Changes Made to Development Permit Documents

Bubbled Set
Changes made to the
Development Permit Application

902 Foul Bay Road
Victoria B.C.

Revised Development Permit Application
April 26, 2024

sheet no. A4.1

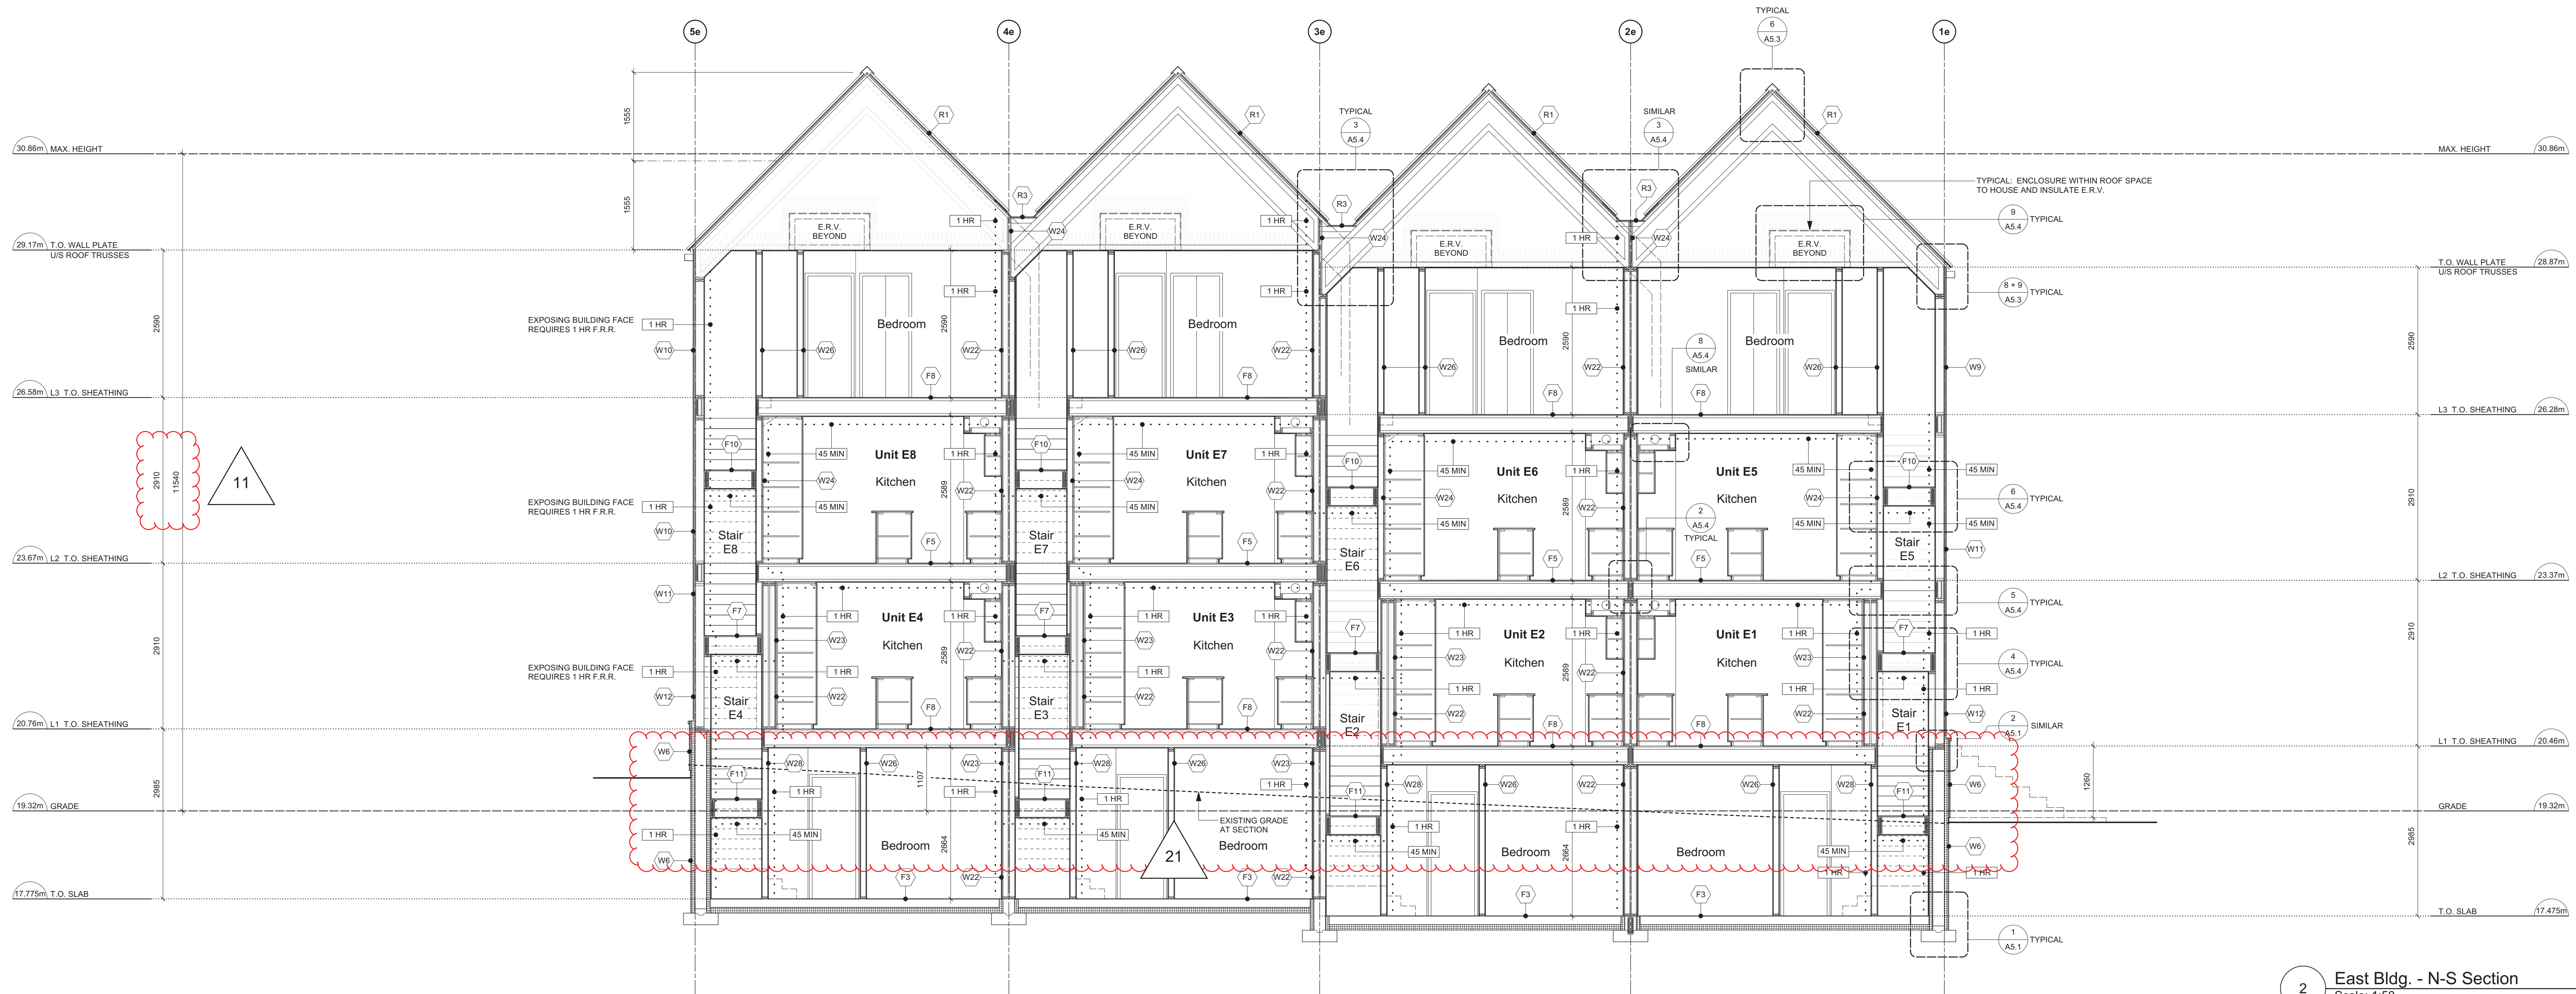
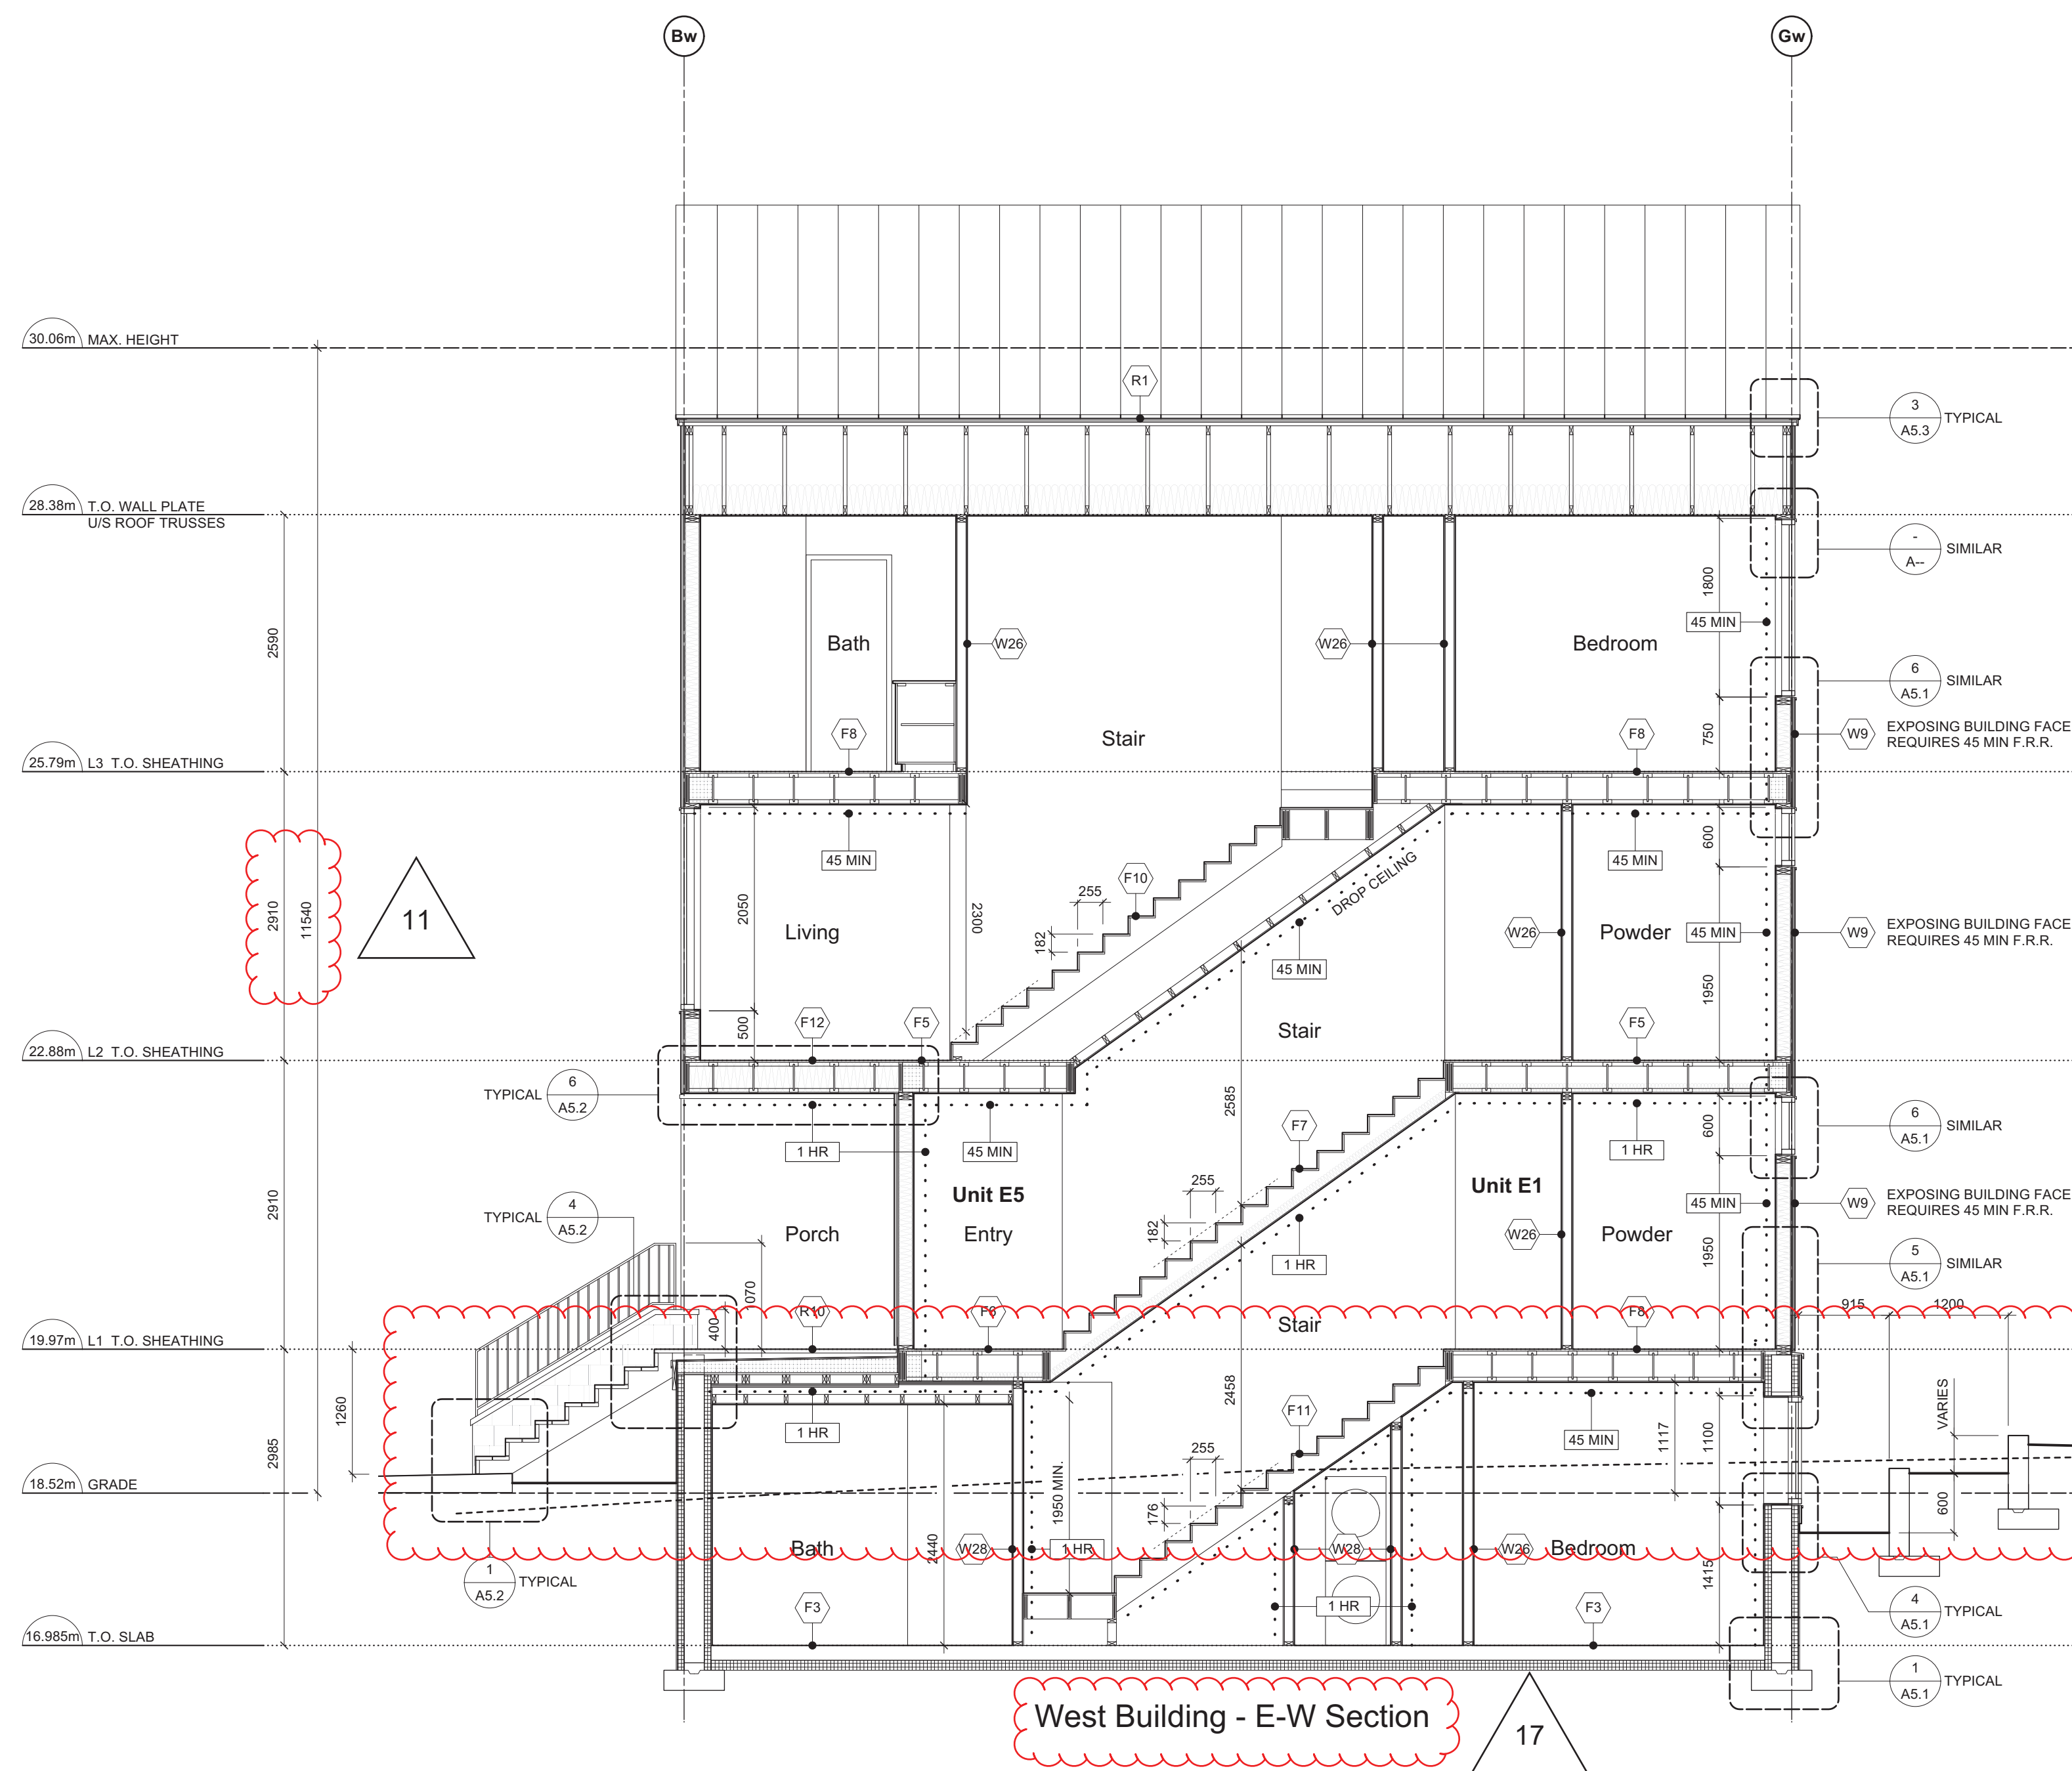
17	Section Label Revised	A4.1	Section drawing labels revised to "East Building", "West Building" and "Site" in response to Zoning Plan Check Comment.
18	Materials Palette Added	A3.4	Added back into set with new sheet number. Material #7 has been deleted and replaced (see revision #6 above).
19	Stairs & Retaining Walls Adjusted	Site Plan & A2.1w	At the West Building, entry porch stairs have been reduced in length and window well retaining walls have shifted east to suit refinements in finished grade. Grade points at retaining walls and new building corners have been re-extrapolated from the survey. See revision #7 above.
20	Stairs Adjusted & New Retaining Walls	Site Plan & A2.1e	At the East Building, window wells have been added and entry porch stairs have been adjusted in length to suit refinements in finished grade. Grade points at new building corners and retaining wall steps have been re-extrapolated from the survey. See revision #7 above.
